PLANNING BOARD

PLANNING BOARD
8th October, 2026

Further to Minute No. 21 of the meeting of the Planning Board held on 16th July, 2026 an update was provided on the latest position with the application by Whitestone Net Zero Ltd. for an order granting development consent for the Whitestone Solar Farm.

Figure 4: WL-02 Indicative Location

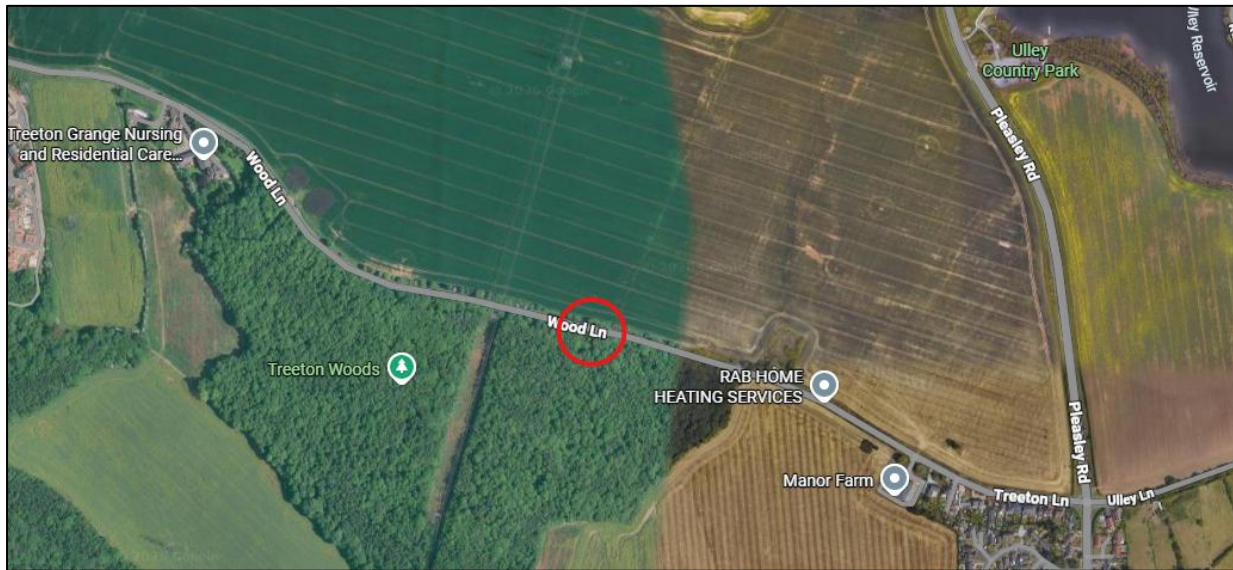
Table 4: WL-02 Review

Figure 6: CCL-01 Indicative Location

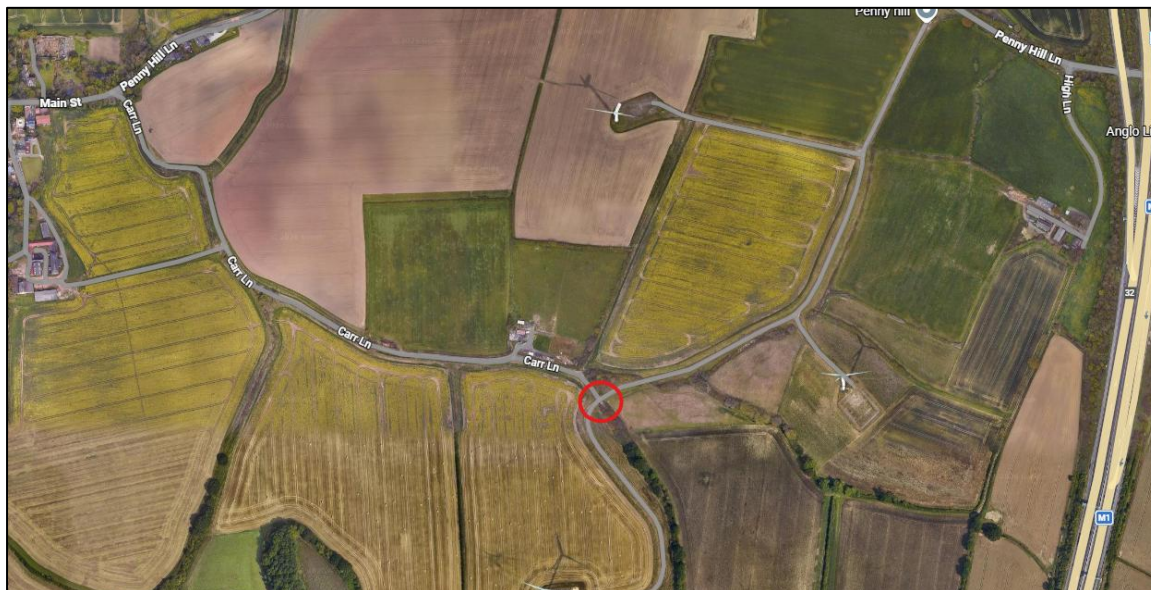
Table 6: CCL-01 Review

Figure 10: CL-01 Indicative Location

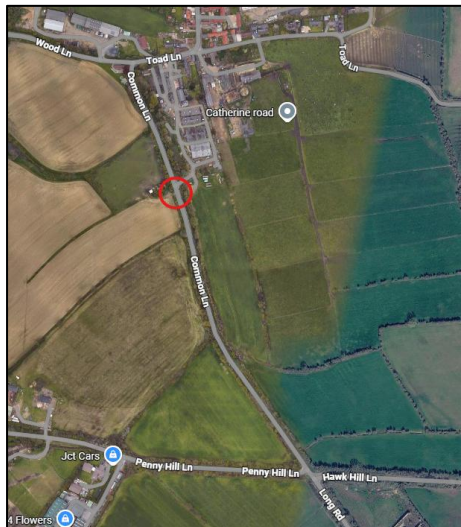
Table 10: CL-01 Review

Figure 14: CL-03 Indicative Location

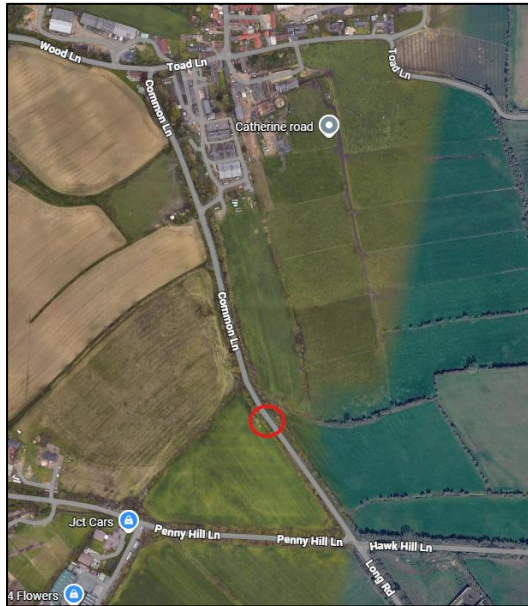
Table 14: CL-03 Review

Figure 20: CC-11 Indicative Location

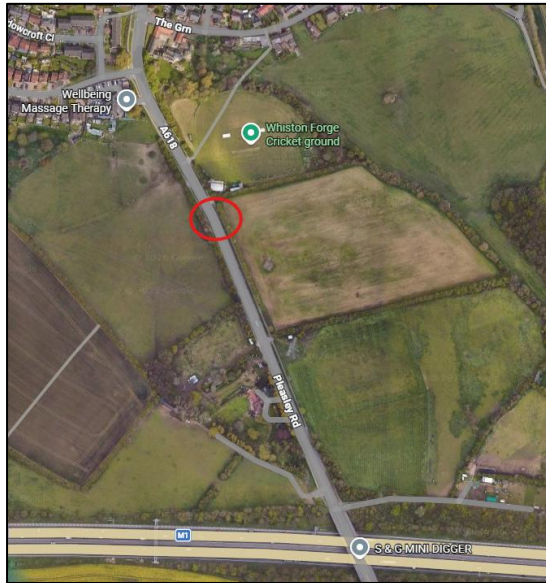
Road Status	
Adopted / Unadopted	Adopted (forms part of the public adopted highway)
Speed Limit	50mph
Applicant's Proposal	
Proposed Visibility Splay	160m to the north and south (DMRB Desirable Minimum SSD compliant for a 50mph speed limit)
Access / Crossing	Access (Cable Corridor Area)
Existing / New Access	New access required along the eastern highway boundary.
Daily Vehicle Access	Estimated 6 HGVs and 10 staff vehicles.
Stantec's Comments	
Horizontal Visibility	Horizontal visibility is achievable , subject to the minor removal of vegetation on the eastern highway boundary to the north and south. Street View imagery indicates that, in the vicinity of the proposed access, the road is generally straight to the south, with minor horizontal curvature to the north. Further to a site visit, it was observed that no horizontal constraints to the achievement of the proposed visibility splay are present.
Vertical Visibility	Vertical visibility to the north is achievable. However, further to a site visit, it was observed that vertical visibility to the south is not achievable . Street View imagery indicates that, in the vicinity of the proposed access, the road generally follows a north-south gradient, falling towards the north and rising towards the south, with a notable blind crest located to the south.

Figure 21: CC-13 Indicative Location

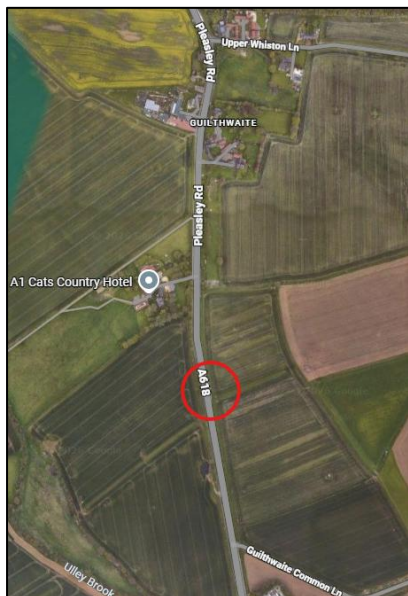
Vertical Visibility	Vertical visibility to the north is achievable . However, further to a site visit, it was observed that vertical visibility to the south is not achievable . Street View imagery indicates that, in the vicinity of the proposed access, the road generally follows a north-south gradient, falling towards the north and rising towards the south, with a notable blind crest located to the south.

Figure 22: CC-14 Indicative Location

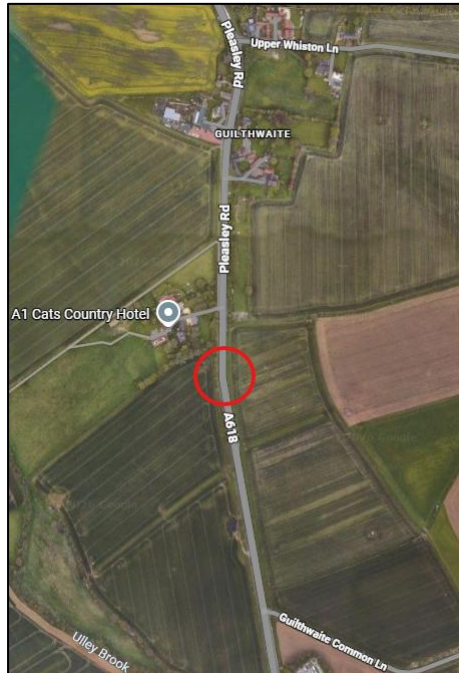
Road Status	
Adopted / Unadopted	Adopted (forms part of the public adopted highway)
Speed Limit	60mph
Applicant's Proposal	
Proposed Visibility Splay	215m to the north and south (DMRB Desirable Minimum SSD compliant for a 60mph speed limit)
Access / Crossing	Access (Cable Corridor Area)
Existing / New Access	New access along the western highway boundary.
Daily Vehicle Access	Estimated 24 HGVs and 36 staff vehicles.
Stantec's Comments	
Horizontal Visibility	Horizontal visibility is achievable , subject to the minor removal of vegetation on the western highway boundary to the north and south. Street View imagery indicates that, in the vicinity of the proposed access, the road is generally straight with no significant horizontal curvature. Further to a site visit, it was observed that no horizontal constraints to the achievement of the proposed visibility splay are present.
Vertical Visibility	Vertical visibility is achievable . Street View imagery indicates that, in the vicinity of the proposed access, the road generally follows a north-south gradient, falling towards the north and rising towards the south, with a notable crest located to the south. Further to a site visit, it was observed that no vertical constraints to the achievement of the proposed visibility splay are present.

Figure 23: POHL-02 Indicative Location

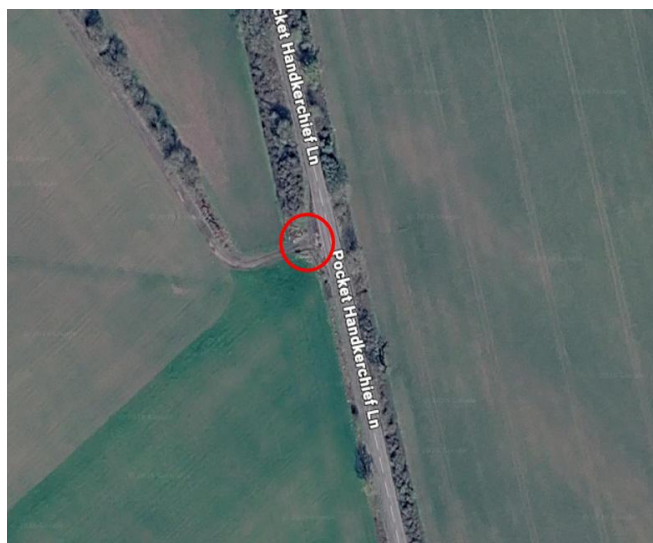
Table 23: POHL-02 Review

Figure 3: GCL-02 Location

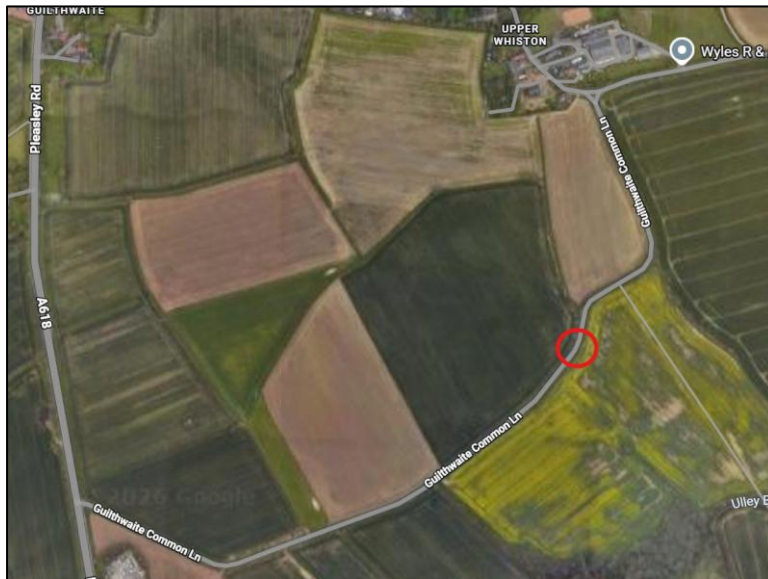
Road Spec	Speed Survey	Survey Vis Splay	Requirements	Access / Crossing
60mph – DMRB 215m desirable minimum SSD	43 mph	113m desirable minimum. 88m absolute minimum.	Reduced vis splay proposed.	Access
